Departmental Comments	Responses to Comments
1.	Comments from Buildings Department	
1.1	Detailed comments on compliance with the Buildings Ordinance would be given upon formal building plans submission.	Noted.

2.	Comments from Lands Department	
2.1	The concerned “Commercial(7)” zone (“the “C(7)” zone”) comprises Cityplaza, 1111 King’s Road (formerly known as Cityplaza One) and Hotel East Hong Kong which are erected on various sections / sub-sections of Quarry Bay Marine Lot No. 2 and the Extension Thereto (i.e. QBML 2 & Ext S.J RP, QBML 2 & Ext S.R RP, QBML 2 & Ext S.R ss.2, QBML 2 & Ext S.Q RP, QBML 2 & Ext S.Q ss.2 s.B, QBML 2 & Ext S.R ss.1 s.A, QBML 2 & Ext S.Q ss.2 s.A RP, QBML 2 & Ext S.Q ss.2 s.A ss.1, QBML 2 & Ext S.Q ss.7 RP and QBML 2 & Ext S.Q ss.7 s.A) and the lease term of Quarry Bay Marine Lot No. 2 and the Extension Thereto is 999 years from 18.4.1900. As far as the abovementioned sections / sub-sections of Quarry Bay Marine Lot No. 2 and the Extension pertaining to the “C(7)” zone are concerned, please note that the Government Lease of Quarry Bay Marine Lot No. 2 and the Extension as varied by the relevant Deeds of Variation all dated 12.9.1975 and by two consent le

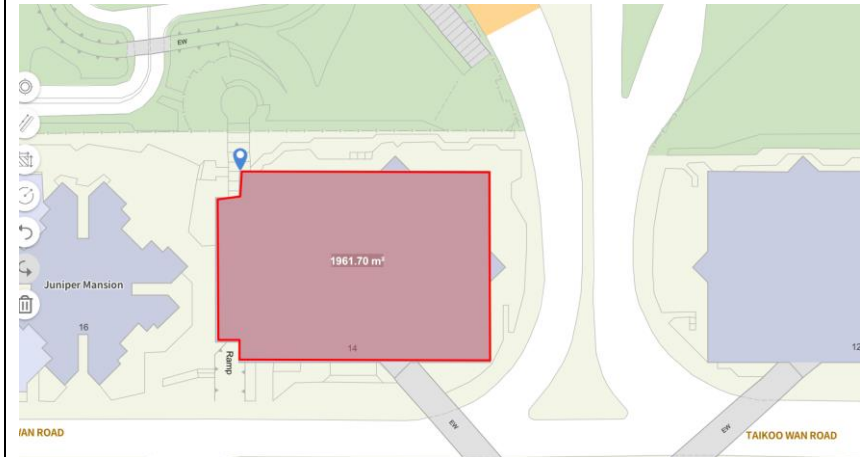
2.4	<p>The site boundary, site area and GFA figures and relevant details of the concerned lots as mentioned in the Planning Statement (PS) have not been verified at this stage. We reserve our position and comments on the</p>	Noted.

Departmental Comments	Responses to Comments
	<p>extent of compliance with the Government Lease, which will be provided upon receipt of the relevant submissions for compliance checking under the Government Lease. Meanwhile, the applicant should ensure that the proposed development should be confined within the concerned lots and would not encroach onto the adjoining Government Land. Reference should be made to Lands Administration Office Practice Note Issue Nos. 4/2008 and 1/2017 issued by LandsD.</p>	
	<p><u>Specific Comments</u></p>	
<p>2.5</p>	<p>The subject submission is intended to extend the office development by adding 13 new storeys of office, mechanical & electrical facilities and refuge floor-cum-sky garden atop the existing building of 1111 King's Road (“the proposed development”) through relaxation of GFA of “C(7)” zone from 123,129m² to 148,629m² (i.e. increase 25,500m²) and BH restriction of the site of 1111 King's Road from 135mPD to 165mPD (i.e. increase 30m) under the OZP. Please note that the lots where the “C(7)” zone situated thereon form parts in the MDP. The total proposed commercial GFA and BH (incl. no. of storeys and heights of buildings) would exceed those stipulated in the MDP governing the concerned lots and therefore not acceptable from lease point of view. Should the Town Planning Board (TPB) approve the planning application, the applicant, the concerned lot owners and the relevant parties are required to apply to LandsD for prior written consent (for necessary amendments of the MDP) in order to implement the proposed development. However, there is no guarantee that such application, if submitted, will be approved. Such application, if received, will be dealt with by LandsD acting in a capacity as the landlord at LandsD's discretion, and if it is approved, it will be subject to such terms and conditions including amongst others, payment of appropriate premium and fees as may be imposed by LandsD.</p>	<p>Noted.</p>

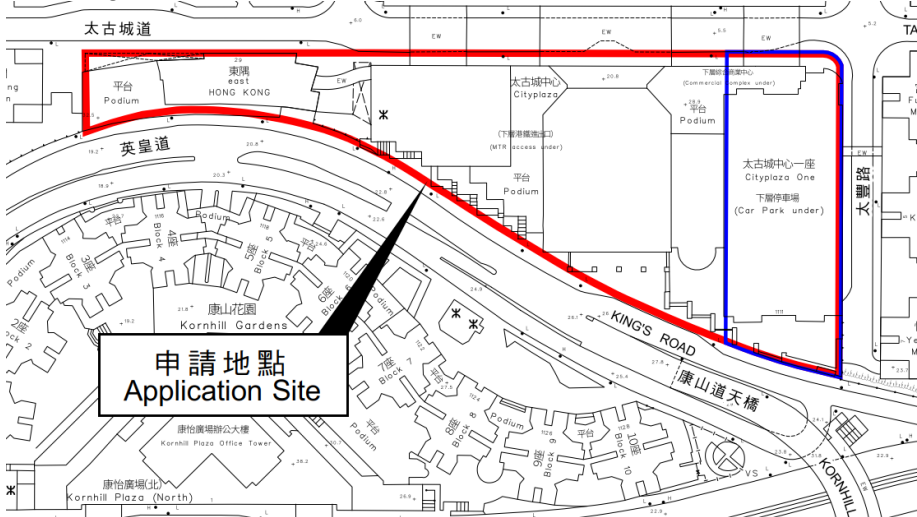
Departmental Comments	Responses to Comments
4.2	<p>For Item 1.4 of RtC, GFA of 28,586m² for east Hong Kong in Catchment B and GFA of 29,690m² for east Hong Kong in Catchment C cannot be found in Appendix 2.1, please advise. Please substantiate with screen captures for your area measurement of (i) east Hong Kong, (ii) 14 Taikoo Wan Road and (iii) 12 Taikoo Wan Road in GeolInfo Map.</p>	<p>GFA figures are revised as shown below:</p> <p><u>(i) GFA for Cityplaza (under Horizon Gardens) in Catchment B:</u> 8,445m² x 4 storeys x 80% = 27,024m² ; <u>GFA for Cityplaza (under Horizon Gardens) in Catchment C:</u> 8,562m² x 4 storeys x 80% = 27,398m²</p>

(ii) GFA for 14 Taikoo Wan Road is revised to = 1,962m² x 21 storeys
x 80% = 32,962m²

(iii) GFA for 12 Taikoo Wan Road is revised to = 2,471m² x 21 storeys
x 80% = 41,512.8m²
